#### **Addendum 128– UN Regulation No. 129**

#### **Revision 2 – Amendment 2**

Supplement 2 to the 02 series of amendments – Date of entry into force: 19 July 2018

#### **Uniform provisions concerning the approval of Enhanced Child Restraint Systems used on board of motor vehicles (ECRS)**

Figure 2

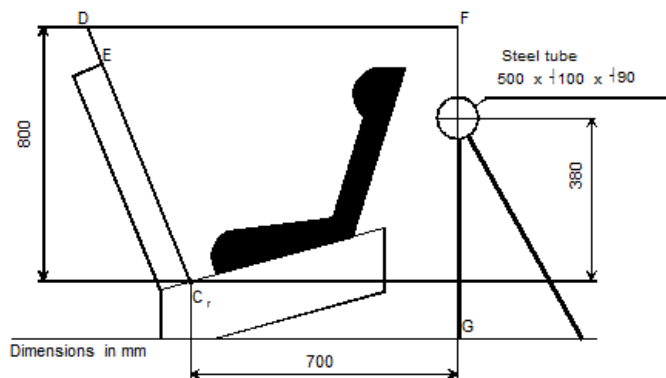
*Paragraph 6.6.4.1.2.1.*, amend to read:

"6.6.4.1.2.1. Head excursion: no part of the head of the dummy shall pass beyond the planes FD, FG and DE, as shown in Figure 2 below. This shall be judged up to 300 ms or the moment that the dummy has come to a definitive standstill whatever occurs first.

Except when testing using Q6 dummy where:

The value in relation to the FD plane is 840 mm

Where a test is conducted with paragraph 6.6.4.1.6.2. or paragraph 6.6.4.1.8.2. above, only the second configuration test results without 100 mm diameter bar will be considered.

Figure 1

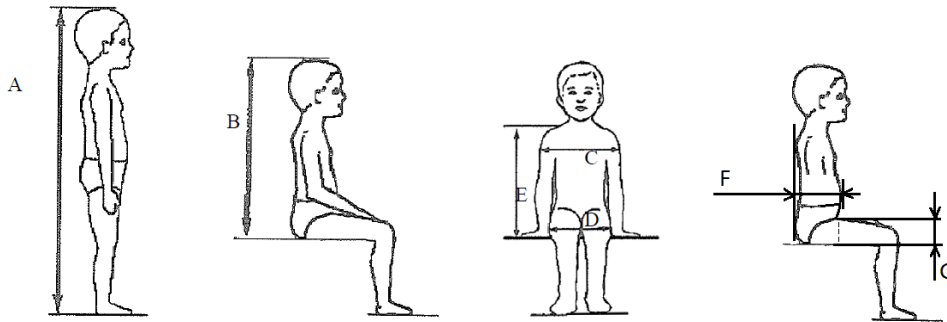
Annex 18, amend to read:

### Geometrical dimensions of Enhanced Child Restraint Systems

Figure 2  
**ECRS Measurement Device - Side and Front View of the measuring device**

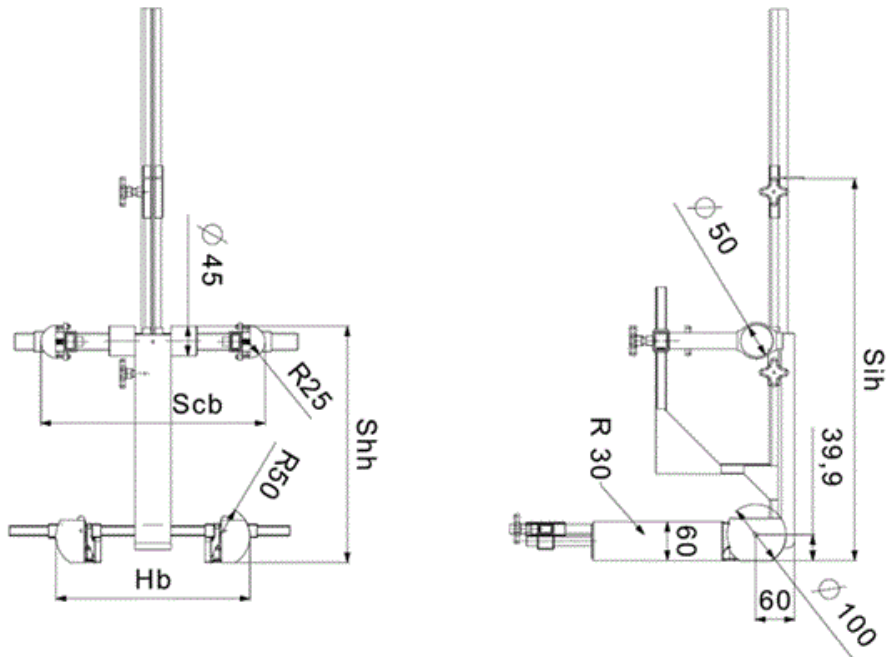
All lateral dimensions are measured under a contact force of 50 N with the devices described in Figure 2 and Figure 3 of this annex and the following tolerances will be applied:

The mass of the devices described in Figure 2 and Figure 3 of this annex shall be 10 kg +/- 1 kg

For integral or non-integral ECRS the device shown in Annex 18, Figure 2 shall be used.

Figure 3  
**Side and Front View of the measuring device for measurements applicable to Enhanced Child Restraint Systems that feature an impact shield**

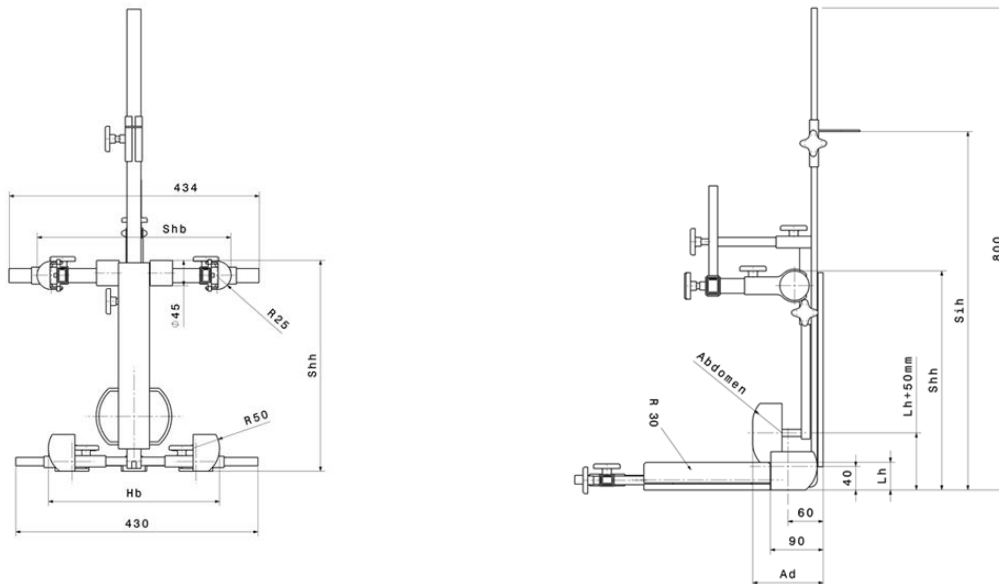
For ECRS with an impact shield the device shown in Annex 18, Figure 3 shall be used.
